United States Nuclear Regulatory Commission Official Hearing Exhibit	
In the Matter of:	Entergy Nuclear Operations, Inc. (Indian Point Nuclear Generating Units 2 and 3)
	ASLBP #: 07-858-03-LR-BD01
	Docket #: 05000247   05000286
	Exhibit #: NYS000437-00-BD01
	Admitted: 10/15/2012
	Rejected:
Other:	Identified: 10/15/2012
	Withdrawn:
	Stricken:

In re: Docket Nos. 50-247-LR; 50-286-LR

License Renewal Application Submitted by ASLBP No. 07-858-03-LR-BD01

**PRE-FILED WRITTEN REBUTTAL TESTIMONY OF**  
**DAVID A. SCHLISSEL**  
**REGARDING CONTENTION NYS-37**

1 **Figure 1: Cumulative Capacity Additions After 2012 in New York State**  
2 **and New England in Entergy's Baseline Analysis**

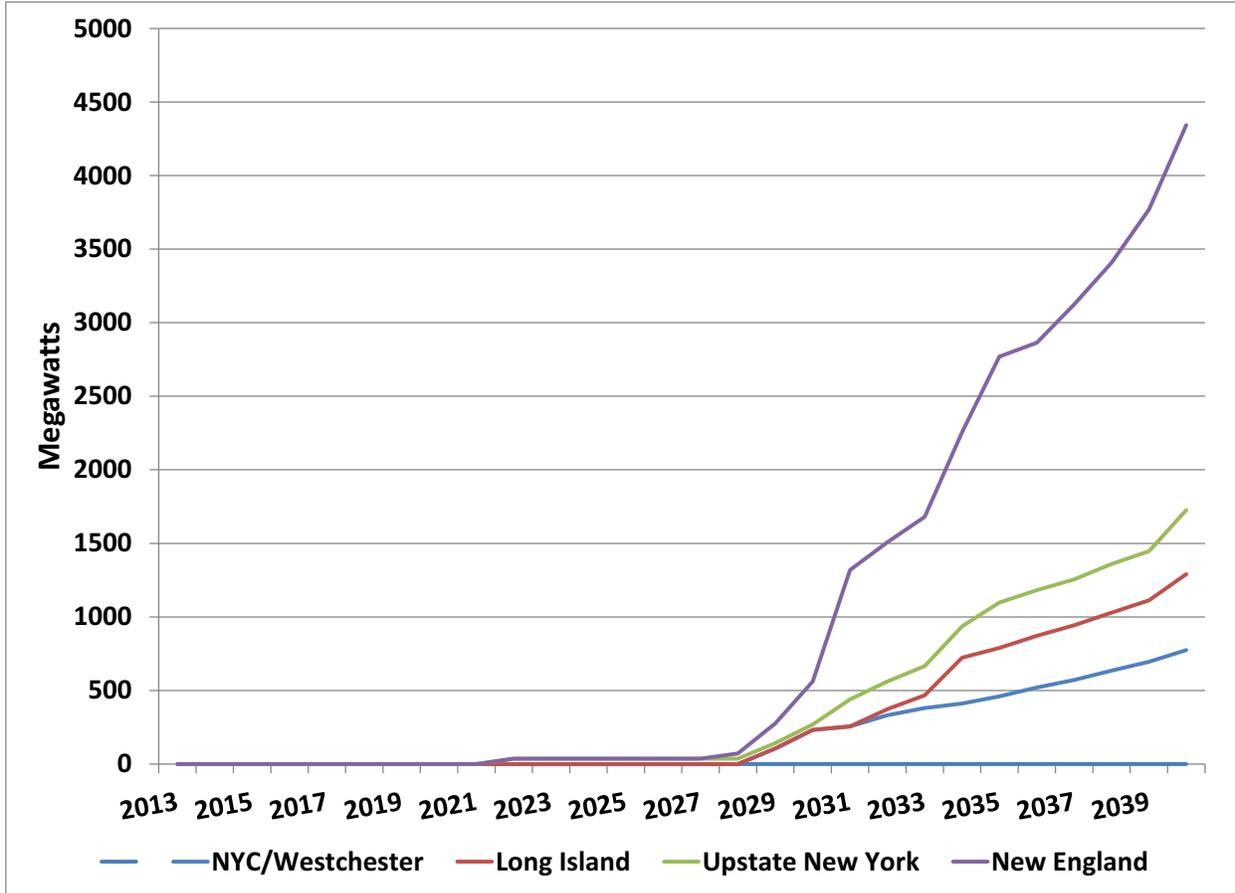
7 A. Figures 1 and 2, below (taken from the outputs for  
8 Entergy's NEMS modeling) show the cumulative megawatts of  
9 capacity added in New York State and New England under Entergy's  
10 Baseline analysis (Figure 1) and the No Action Alternative  
11 (Figure 2). Figure 3 then shows how much capacity is added  
12 under the No Action Alternative above that which would be added  
13 in the Baseline analysis. This represents the capacity added as  
14 a result of the retirement of Indian Point Units 2 and 3.

3  
 4 Q. What do Figures 1, 2 and 3 reveal about the results of  
 5 Entergy’s NEMS modeling of the No Action Alternative?

6 A. In Entergy’s NEMS modeling of the No Action  
 7 Alternative:

- 8 • No clean and efficient replacement capacity is added  
 9 in New York State (let alone New York City and/or  
 10 Westchester) until 2026 and only a relatively small  
 11 amount (300 MW in total) is added in the years 2026  
 12 through 2040.
- 13 • No clean and efficient replacement generating capacity  
 14 would be added in New England until 2025 and then only

1 a relative small amount (110 MW) of new capacity would  
2 be added between 2025 and 2030.<sup>10</sup>

3 Although this result is not reflected in Figure 4, remarkably,  
4 the results of Entergy's NEMS modeling projects that more new  
5 generating capacity would be built in Upstate New York in the  
6 Baseline analysis than under the No Action Alternative.
